**PSE&G** Public Service  
Electric and Gas  
Company

August 20, 1984

HOPE CREEK GENERATING STATION  
DOCKET NO. 50-354  
DRAFT SAFETY EVALUATION REPORT  
OPEN ITEM STATUS

Attachment 1 is a current list which provides a status of the open items identified in Section 1.7 of the Draft Safety Evaluation Report (SER). Items identified as "complete" are those for which PSE&G has provided responses and no confirmation of status has been received from the staff. We will consider these items closed unless notified otherwise. In order to permit timely resolution of items identified as "complete" which may not be resolved to the staff's satisfaction, please provide a specific description of the issue which remains to be resolved.

FIGURE 220.21-5

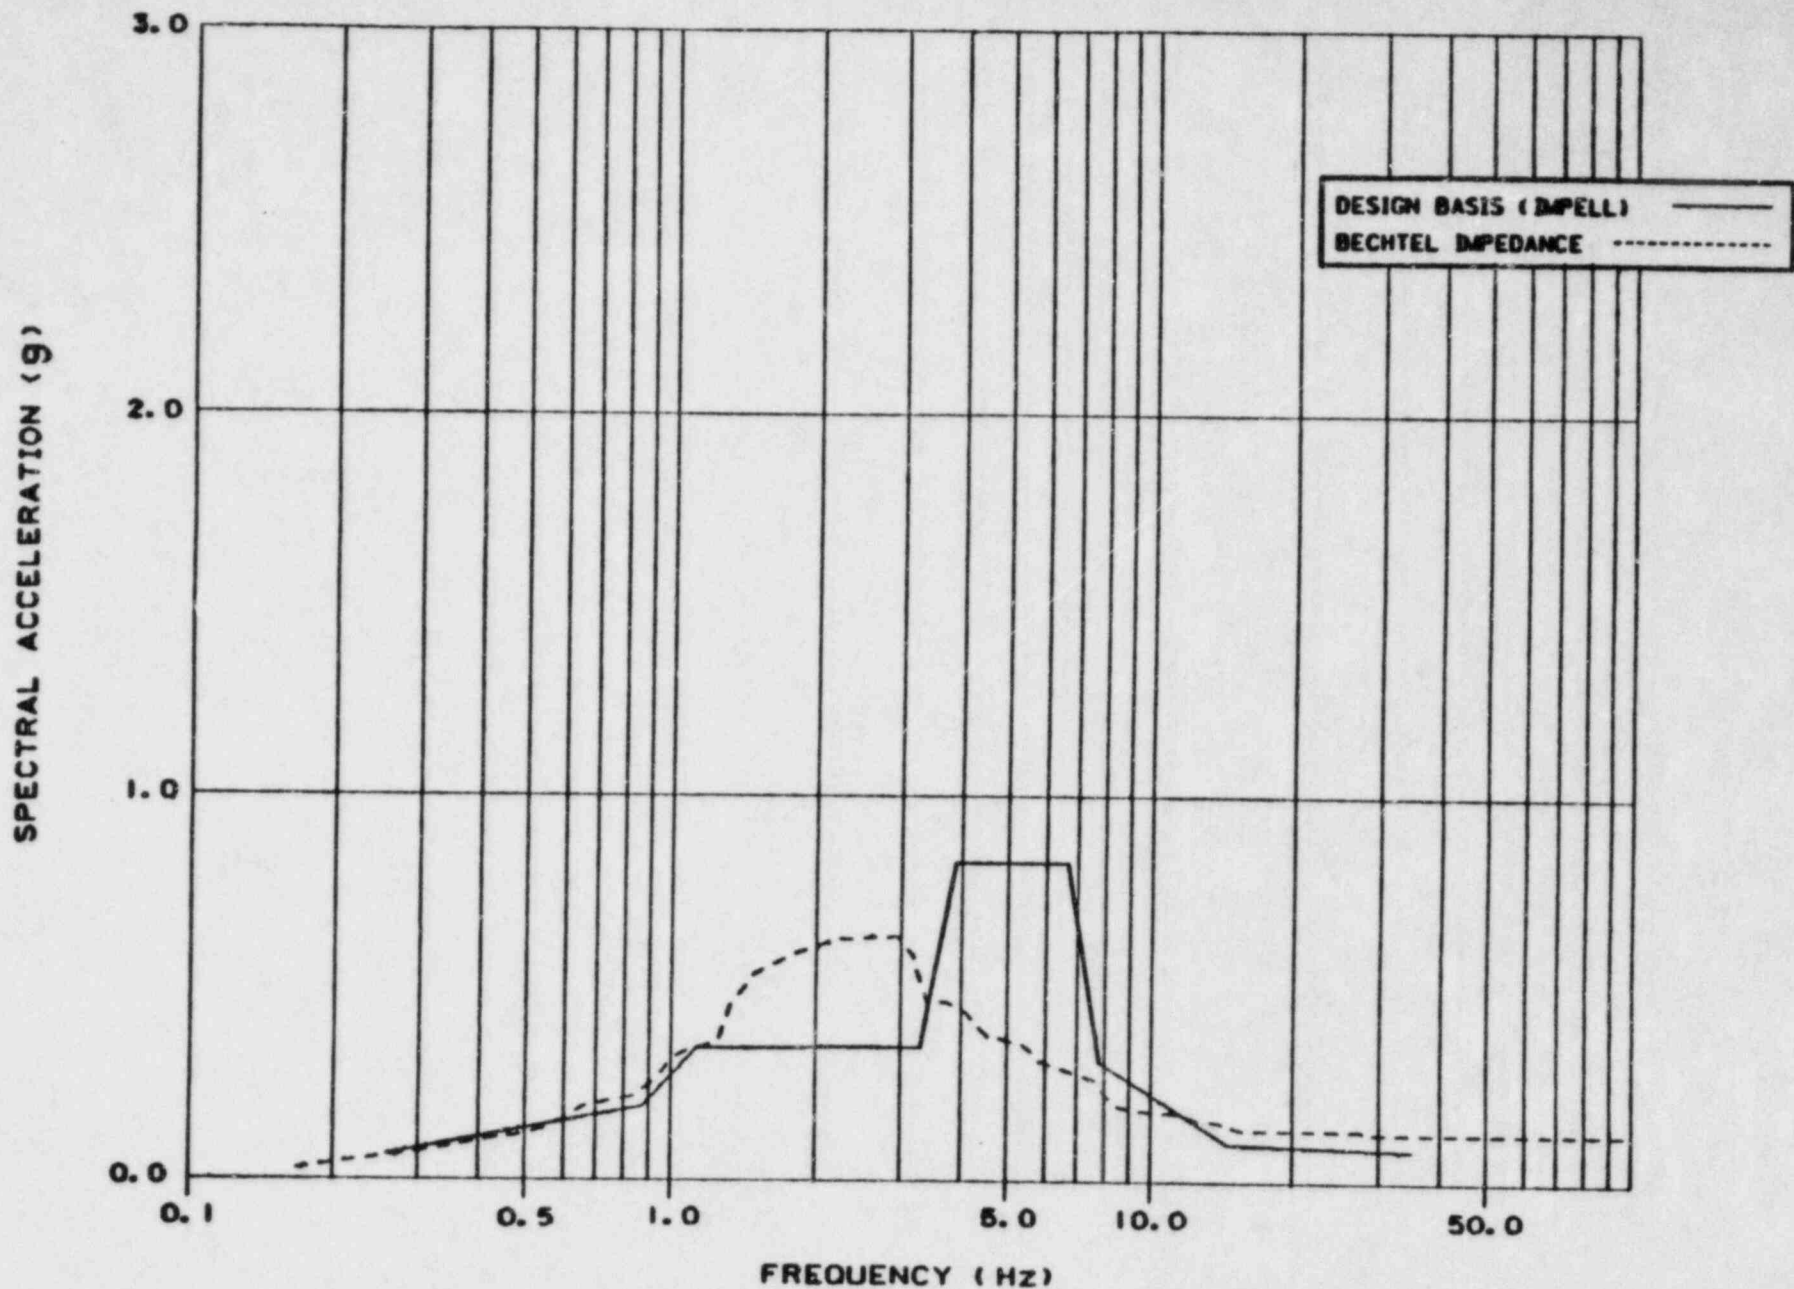
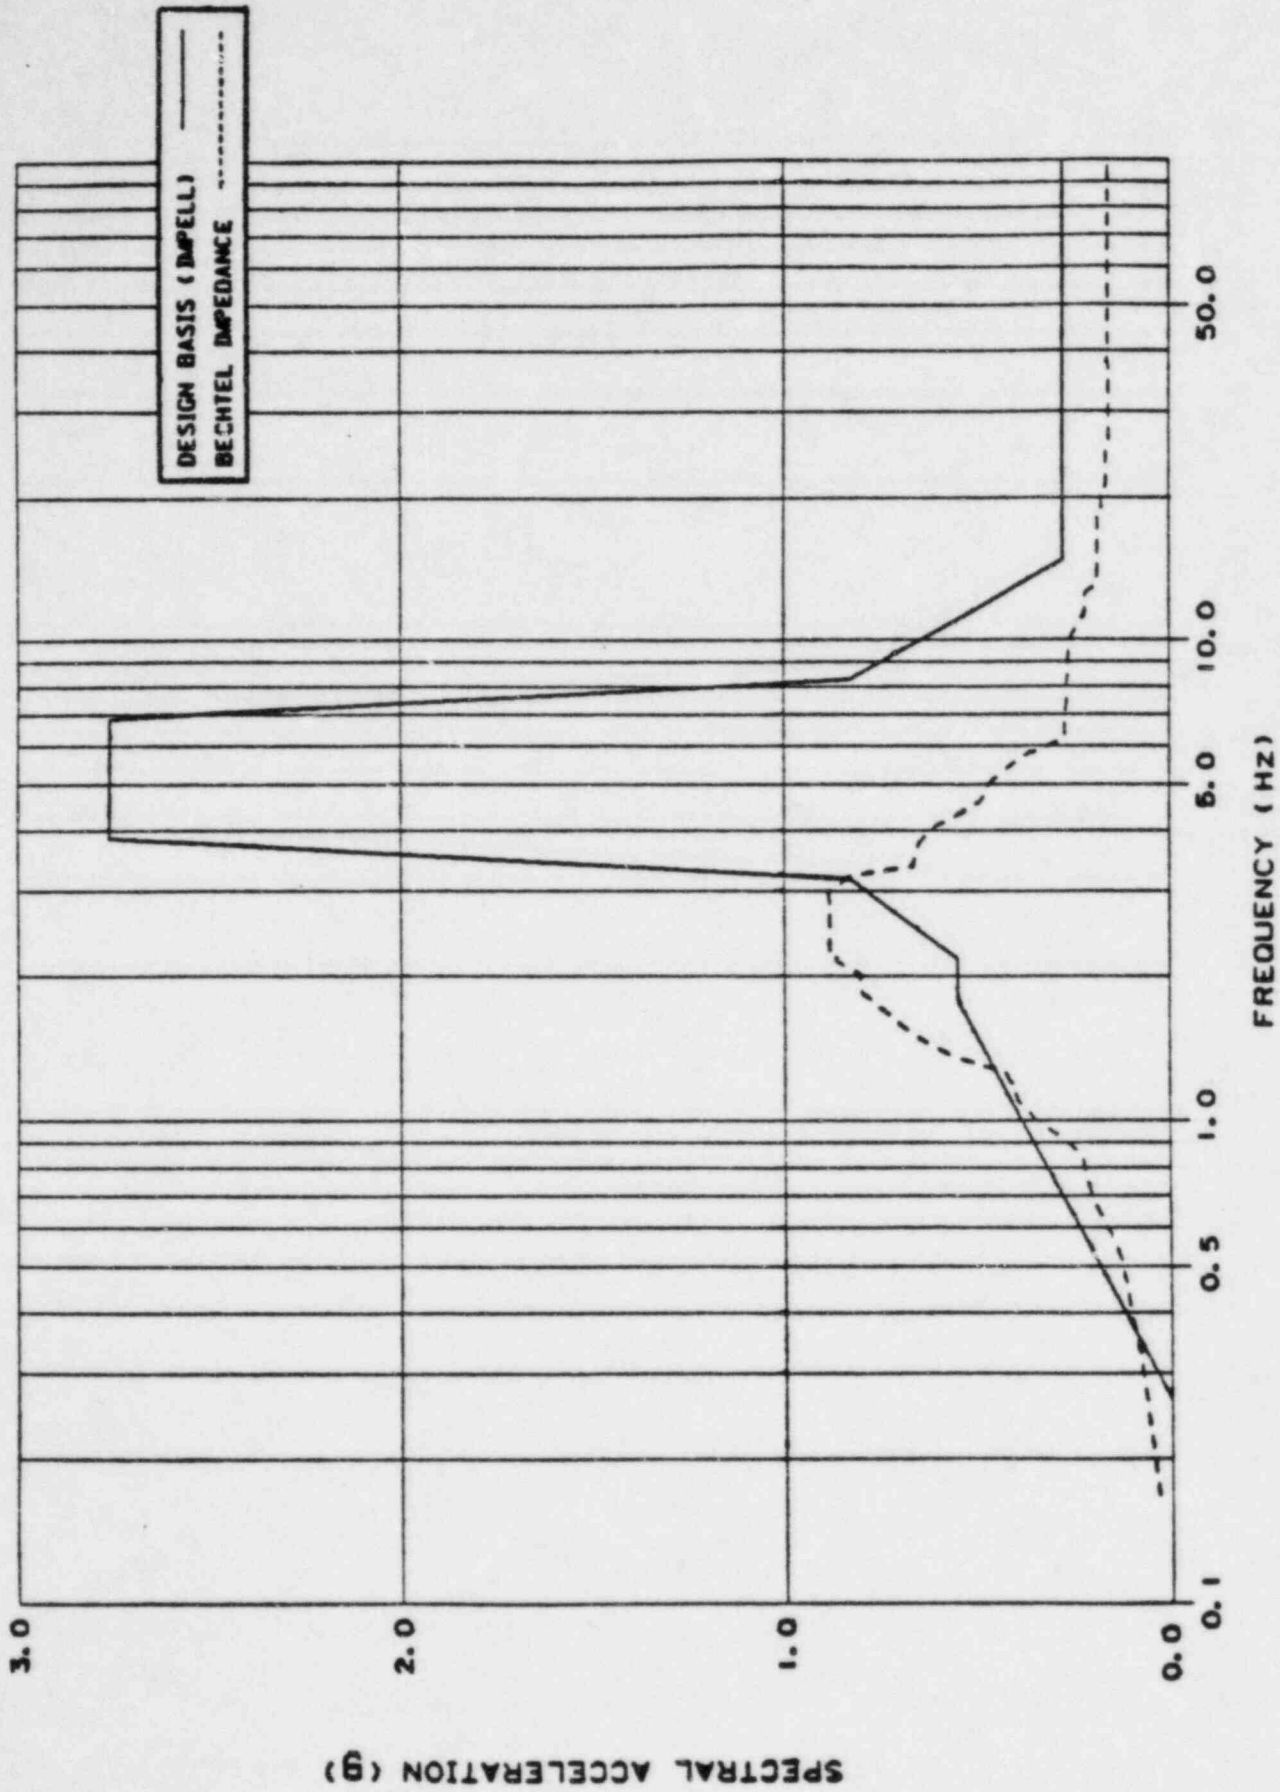
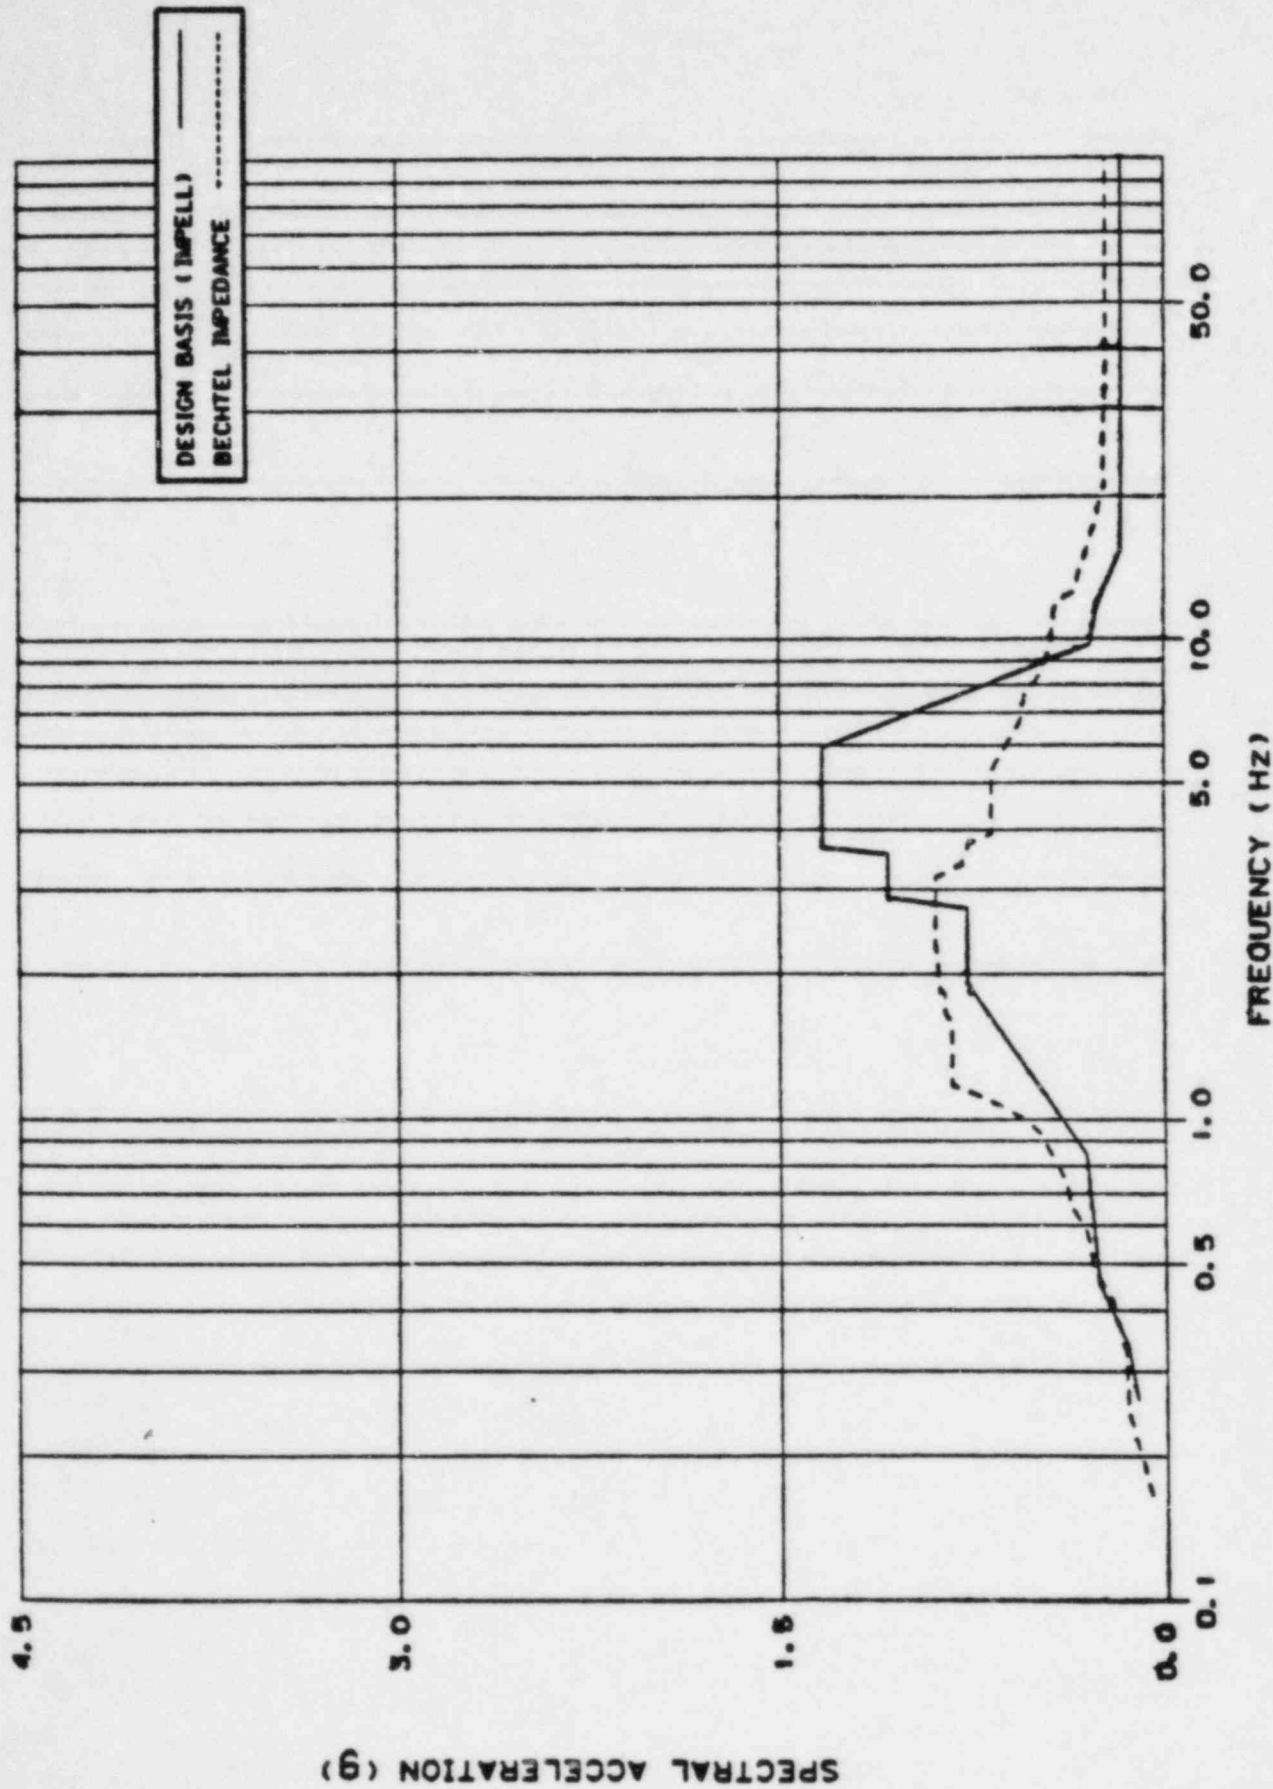
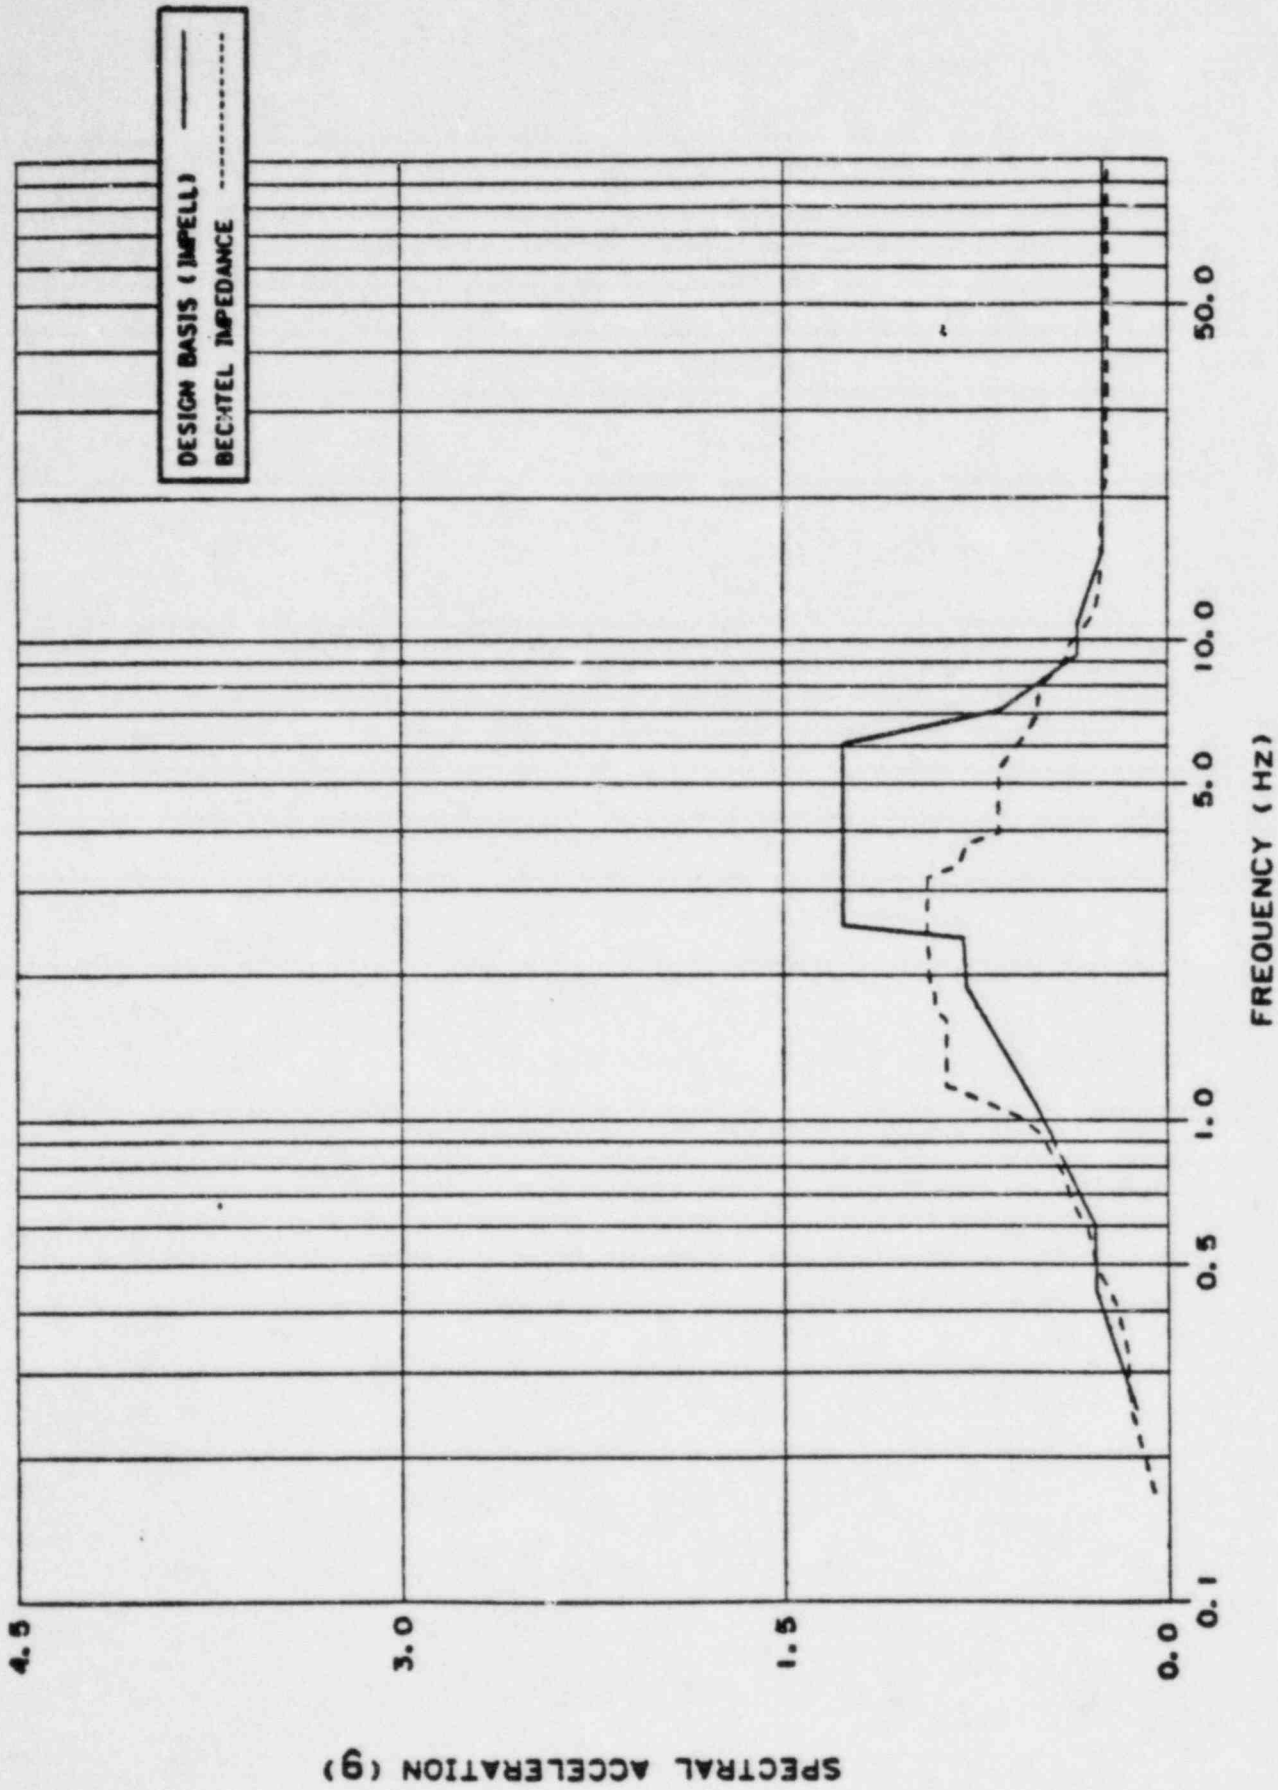
Figures 220.21-1 through 220.21-54 show a comparison of the 2 percent damping response spectra obtained from the design basis finite element and the impedance analyses for the reactor building, auxiliary building and the service water intake structure (SWIS).

¶ For the reactor and auxiliary buildings, the peak spectral accelerations obtained from the impedance analysis are generally lower than those obtained from the design basis analysis. However, the impedance analysis response spectra are not completely enveloped by those obtained from the design basis analysis, especially in the frequency range from 1.0 to 3.5 Hz. Also, there are some local exceedances in the higher frequency range, as shown in Figures 220.21-1 through 220.21-36. ¶ For the SWIS (Figures 220.21-37 through 220.21-54), the impedance analysis response spectra are generally enveloped by those obtained from the design basis analysis at elevation 114.0 feet. For other elevations, the impedance analysis spectral accelerations exceed the design basis spectral accelerations in some frequency ranges. These ranges vary approximately between 1.5 and 10.0 Hz.

In all cases, the items reviewed during these sampling studies can accommodate the loads resulting from the impedance analysis. Therefore, the impedance analysis results have no impact on the plant design.
